Concept Development Application and First Stage of  
Development, 65 Glendale Road, Glendale  
Transport Impact Assessment Addendum

## Transport Impact Assessment Addendum

Client: Transport Asset Holding Entity

TTPP Reference: 22143

**Figure 4.1: Key Modifications**

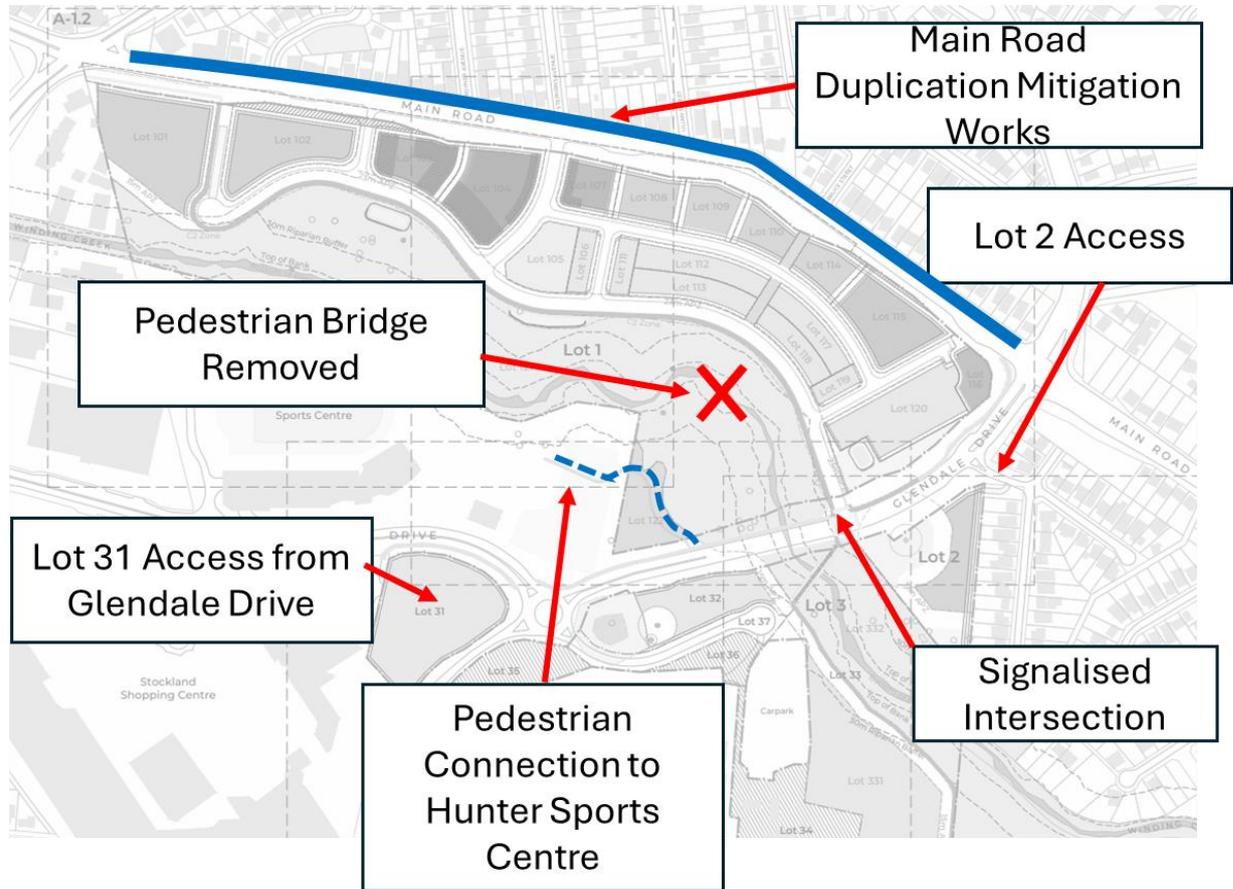
4.2	The proposed pathway network is to be reconsidered to ensure future residents are not required to cross major roads multiple times to access destinations. Where existing pathways are available missing links should be identified and safe access to all stages of the development is to be identified.	<p>The revised plans will include a new connection directly to the Hunter Sports Centre.</p> <p>See Section 4</p>

5.2	The upgrades shown to Main Road on the preliminary concept plans should be extended west to Lake Road to ensure Main Road can function logically and safely as a dual carriageway road between Lake Road and the Stevens Avenue intersection. This extension will be required to ensure the intersections can safely operate together with adequate capacity.	<p>Designs have been updated to show two lanes in each direction between Lake Road and Glendale Drive.</p> <p>See Section 4</p>

5.3	Our preference is for the proposed intersection of lot 1 and Glendale Drive to be signalised. This is to ensure safe crossings can be provided at the intersection for future residents in all directions. If this is not considered suitable, a signalised Pelican Crossing is to be provided south of	<p>The roundabout has been modified to traffic signals to provide safe connection for the regional cycleway route through Lot 1.</p> <p>See Section 4</p>

The updated plan features a number of changes that affect the site and the assessment. The key changes are:

- Signalising the access to Lot 1 from Glendale Drive to support a safe crossing for the regional cycle route.
- Lot 2 access re-located to Scar Tree Way and generally reduced yield forecast for this lot.
- Pedestrian access to the Hunter Sports Centre.
- Removal of the proposed pedestrian and cycle bridge over Winding Creek.
- Mitigation works that include the duplication of Main Road to two lanes in each direction from Lake Road to Glendale Drive (see Appendix B).
- Access for Lot 31 has been relocated to directly from Glendale Drive rather than the previous access off the private road.

The signalising of the Lot 1 access from Glendale Drive is primarily for the purpose of providing a safe crossing for the regional cycleway along Winding Creek and would support active transport in the area.

Pedestrian along the northern side of Stockland Drive was found to be unfeasible and therefore an alternative access from Glendale Drive will be provided through the proposed park area.

**Figure 5.1: Overall Trip Distribution**

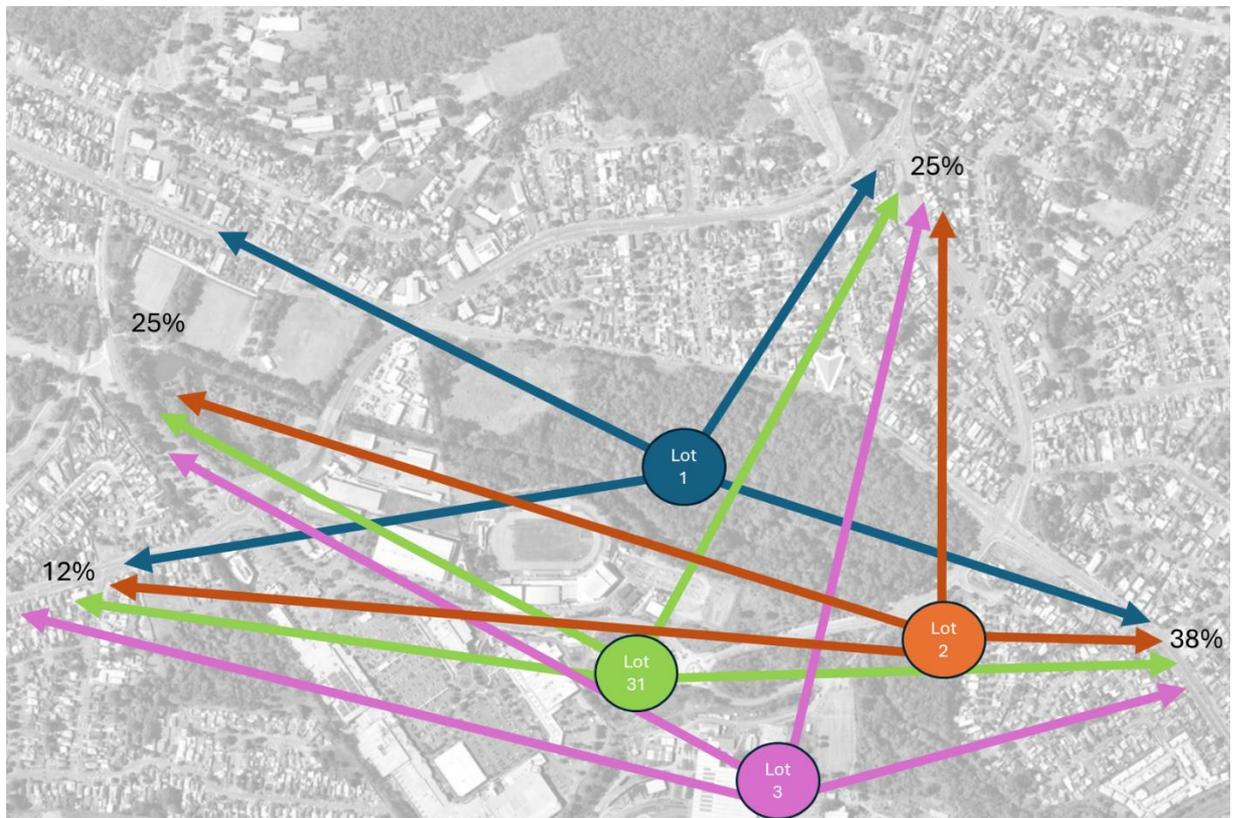
4	Trip distribution through the local network should be shown diagrammatically, not just tabulated. This should include any potential staging of the development.	Diagrams have been created.  See Section 5
5	The SIDRA modelling should be based on the year the development will be completed and then 10 years into the future, not 2022 and 2032.	Modelling has been updated to include 2032 and 2042 based on STFM forecasts.  See Section 7
6	It is not clear why it is assumed there will be a double right turn on the western leg of the intersection of Main Road and Lake Road. It is re-emphasised there are no current funded or committed projects in this area. There is also no pedestrian crossing on the southern leg.	These upgrades have been removed from the forecast.  See Section 5, 6 and 7
7	At the intersection of Main Road and Stephens Avenue: <ul style="list-style-type: none"> <li>The length of the right turn bays on Main Road should accommodate the length of the queues</li> </ul>	These issues are discussed in section 7.7

**Figure 7.1: Intersection of Stephen Avenue – Main Road – Lot 1 Access Road**

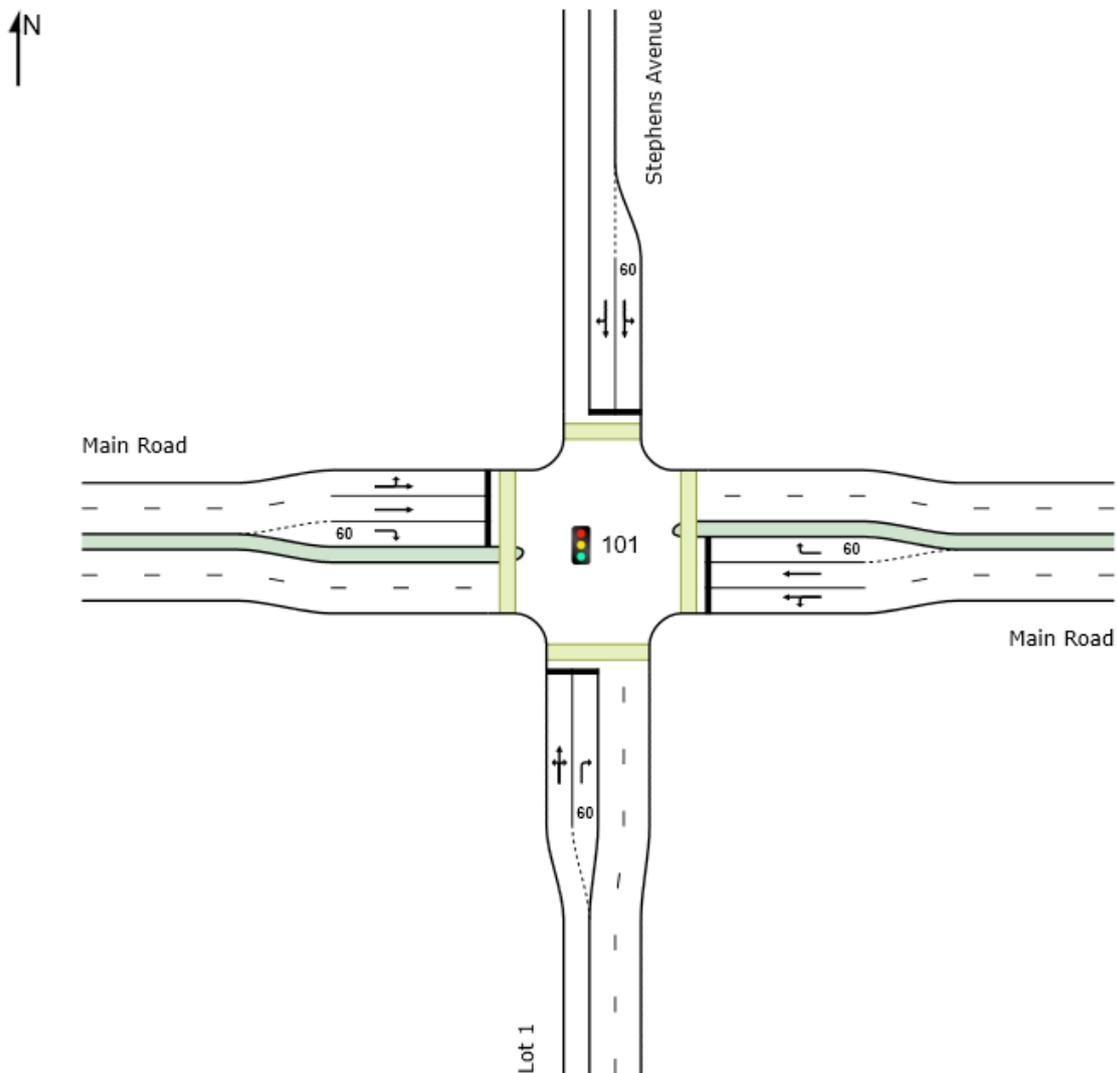
- The length of the right turn bays on Main Road should accommodate the length of the queues
- Provide separate left turn lanes on Main Road
- Consider the opportunity for double diamond phasing (will require configuration on side streets to be changed)

To allow for double diamond phasing would require a dedicated right turn lane. Stephen Avenue is some 11m wide so there would be adequate road width to add a two lane approach if required in the future.
